# Lower Thames Crossing

## 9.89 Responses to the Examining Authority's ExQ1 Appendix F – 10. Road Drainage, Water Environment & Flooding

Planning Inspectorate Scheme Ref: TR010032  
Examination Document Ref: TR010032/EXAM/9.89

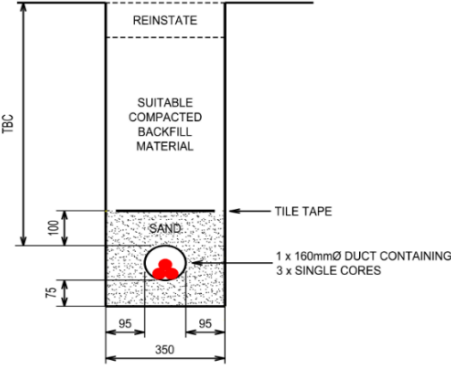
ExQ1_Q10.2.4	N/A	<p><b>Infiltration Pond at Park Pale</b></p> <p>Construction of a gravity highway drainage network incorporating new infiltration basin (Work No. 11 – as shown on sheet 3 of the works plans [APP-019]) is located to the east of the industrial development on Park Pale. On 6 July 2023 (USI-05), on Route 31: Bowesden Lane to Park Pale Farm it was noted that the proposed location of the pond is on land that is currently at a higher level than the existing highway and as such a gravity system is unlikely to work. Additionally, it is at the extremity of the proposed work areas surrounded by land that is to remain unaffected by the proposed works, Work parcel OSC1, 11 and to the north E3 (Ancient Woodland mitigation). The general fall of the land is high ground towards the North and East towards the A2/M2. The existing highway is the low point in the area. - Can these works be implemented as proposed and, if so, how will they be implemented? - Have the potential effects of the excavation and subsequent rakes of banks been considered fully in the ES and other application documents? - What route would exceedance flows that could exit the pond basin follow and could they place existing or proposed infrastructure at risk?</p>

PINS ID	External Stakeholder (where applicable)	Question / Response
		<p><b>Response:</b></p> <p>The infiltration basins have been designed in line with Design Manual for Roads and Bridges (DMRB) standards. The carriageway levels are shown on Engineering Drawings and Sections (Volume C) (A2 M2 and A2 Mainline Plan and Profiles) [APP-032] and confirm that the A2 levels fall towards the eastern end. The A2/M2 mainline carriageway has a low point of 70.5m (sheet 3 of A2 Mainline – plan and profiles [APP-032]) ordnance datum (AOD), the eastbound link road has a low point of 69.9m AOD (sheet 6 of A2/M2 plan and profiles [APP-032]). The proposed invert level to the pond located to the north is at a lower level relative to the highway carriageway at approximately 65.2m AOD, allowing a piped gravity-fed system to be used. It is therefore considered that the proposed approach is feasible and can be accommodated within the Order Limits.</p> <p style="text-align: center;"><b>Plate 2.1 Harlex Drainage</b></p>

PINS ID	External Stakeholder (where applicable)	Question / Response
		<p>This basin includes the catchment of the A2. The new basin lies within a source protection zone, on the boundary between SPZ2 and SPZ3. As such, pollution control will be important. The basin will include pollution control devices as per DMRB CG 501<sup>2</sup> at the inlet along with a lined sedimentation basin at the inlet to improve water quality ahead of the infiltration area. The infiltration area will include infiltration trenches across the invert to maximise infiltration capacity. A penstock chamber will be provided to enable the drainage system to be shut down in the event of an accidental spillage.</p> <p>Infiltration basins in Catchment EFR-1 would be designed to accommodate the runoff generated by a 1 in 100-year storm with a 40% climate change allowance, with an additional remaining freeboard (i.e., space between the top water level and the crest of the basin bunds). There is a residual risk of overtopping, however this is assessed as being very low and would be in response to an exceptional future storm event. Where exceedance flow paths need to be established, as secured by RDWE034 within the Code of Construction Practice [REP3-104], the overtopped flows would be guided towards existing (pre-development) exceedance flow paths. Any civil works required to establish the flow paths would be within the Order Limits but overtopped flows would eventually be discharged to areas where existing exceedance flows naturally gather, which may be beyond the Order Limits.</p>

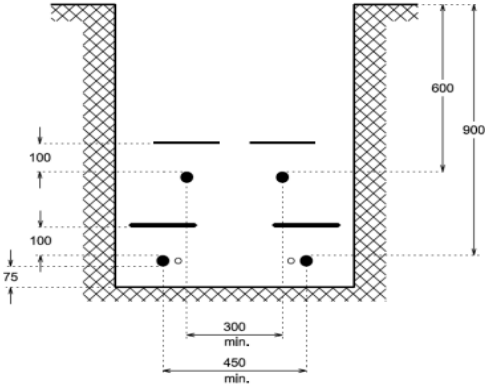
ExQ1_Q10.5.2	N/A	<p><b>Low Street Irrigation Reservoir</b> Also in ES Chapter 14 [APP-152], it is suggested in paragraph 14.5.15 that: “o. The Low Street irrigation reservoir (located at Easting 567,023 and Northing 177,780) is groundwater fed. Utility corridors are proposed to the east, west and north of the reservoir (Work No. MU28 and Work No. MU33) and have the potential to form a barrier to groundwater flow, cause draining of groundwater that would otherwise flow towards the unlined reservoir or cause direct drainage from the reservoir. The spatial arrangement of the utility corridors and the below-ground materials shall be designed to prevent drainage from the reservoir, or barrier effects reducing groundwater flow to the reservoir (RDWE054).” Could the Applicant provide possible solutions at this stage to show that this can be delivered and are there any solutions that cannot be accommodated within the current Rochdale Envelope?</p>

PINS ID	External Stakeholder (where applicable)	Question / Response
		<p><b>Response:</b></p> <p>Typical open cut trench material configuration and materials are shown in ES Appendix 14.5: Hydrogeological Risk Assessment, Annex Q [APP-459], including Table 1.2 of the same annex. Given the typically shallow depths, shown in Table 1.1 of Annex Q, potential draining and barrier effects are likely to be small or absent. However, following a precautionary approach, commitment RDWE054 in ES Appendix 2.2: Code of Construction Practice (CoCP) [REP3-104] commits the Project to require the Contractors to consider reducing potential draining effects or barrier effects caused by utility corridors near the reservoir when designing the listed utility corridors. This would be done within the limits of deviation allowed for within the application. Further detail is presented below.</p> <p>The Contractors will develop the design for the installation of utilities around the reservoir and look to prevent adverse impact to groundwater flow to and from the reservoir. Standard methods of construction that would achieve this are as follows:</p> <p>For Work No MU28 and Work No MU33:</p> <ol style="list-style-type: none"> <li>The standard approach for the installation of these assets would be to install a ducted system via an open cut trench; the trench size and duct formation would be developed to fit the site constraints, but the general arrangement of the trench would be similar to those depicted in the cross section below.</li> </ol> <p style="text-align: center;"><b>Plate 2.2 Typical electricity network trench for a single duct</b></p>

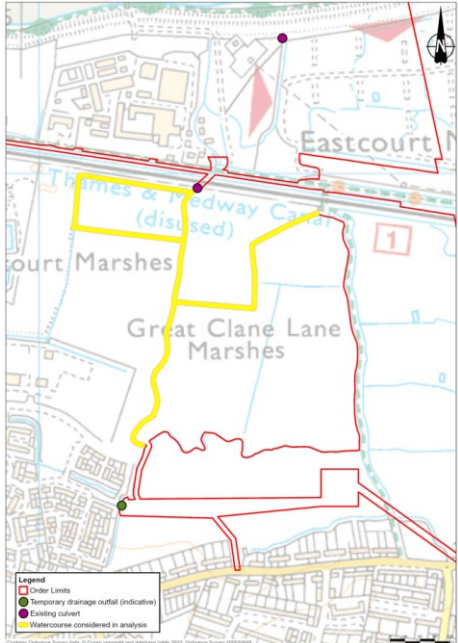
ExQ1_Q10.6.3	N/A	<p><b>Discharge to the River Thames</b></p> <p>Paragraph 4.1.1 of Appendix 14.4 Hydromorphology Assessment <a href="#">[APP-457]</a> suggests that there are no effects on any surface water features. However, during the construction phase, it is proposed to discharge treated rainfall runoff (southern entrance) to a ditch in Filborough Marshes. - Is the ditch designated as a “Main River” or an ordinary watercourse? - Who is drainage authority? - Is discharge ditch going to be tidelocked and if so, what are consequences? - Would it have the potential to affect any other watercourses in the catchment, and if so, have the effects been considered in the submission or have they been part of watercourses that have been</p>

PINS ID	External Stakeholder (where applicable)	Question / Response
		<p>excluded from the analysis? - If the tributaries have been excluded, what are the potential effects on the proposals if there are potential detrimental effects determined?</p> <p><b>Response:</b>                      The ditch that is proposed to receive the discharge of treated rainfall runoff from the southern tunnel entrance compound (referred to in the Application as the western ditch) is designated as a main river and the Environment Agency is the drainage authority. The ditch has a reach length from the proposed discharge outfall location to the outfall to the River Thames of approximately 880m, and joins to a connecting network of ditches (illustrated in Plate 2.5), effects on all of which have been considered in the submission.</p> <p style="text-align: center;"><b>Plate 2.5 Ditches considered in the analysis of effects from the Project's proposed temporary outfall</b></p>  <p>The map shows a network of ditches and watercourses. A red line indicates the Order Limits. A blue line with a black dot indicates the Temporary drainage outfall (indicative). A green line indicates an Existing outfall. A yellow line indicates a Watercourse considered in analysis. The map also shows the River Thames and the disused Thames &amp; Medway Canals. The area is labeled as Eastcourt Marshes and Great Clane Lane Marshes.</p>

PINS ID	External Stakeholder (where applicable)	Question / Response
		<p>The ditch network discharges via a flapped outfall into the River Thames, so is subject to tide locking. This has been considered in the design of the proposed runoff storage and treatment system. Calculations have been completed to quantify the effects of the additional volumes of discharge on water levels in the receiving western ditch and connecting ditches, including during tide locking when the ditch network stores water, at a typical depth (from observations) of approximately 1m. These calculations were shared with Natural England and the Environment Agency in agreeing the approach set out in the application. To reduce baseline water level change in the ditch network it is proposed to provide sufficient storage within the compound drainage treatment area to allow for discharges not to exceed the 1 in 1 year event runoff volume under tide locked conditions. This is secured by commitment RDWE033 within the Code of Construction Practice <a href="#">[REP3-104]</a>. These calculations have been shared with the Environment Agency and, as detailed in the Statement of Common Ground between the Applicant and the Environment Agency (item 2.1.2) <a href="#">[REP1-058]</a> it was agreed that an environmental permit would be obtained from the Environment Agency for the discharge. This has been secured by Project commitment RDWE033 'Discharge from construction of South Portal'. An agreement that there would be an application for an environmental permit was suggested by the Applicant to provide certainty of the protection of the water quality within the Filborough Marshes which form part of the Thames Estuary and Marshes SPA and is considered in detail within the Habitats Regulations Assessment Screening Report and Statement to Inform An Appropriate Assessment <a href="#">[APP-487]</a>.</p>
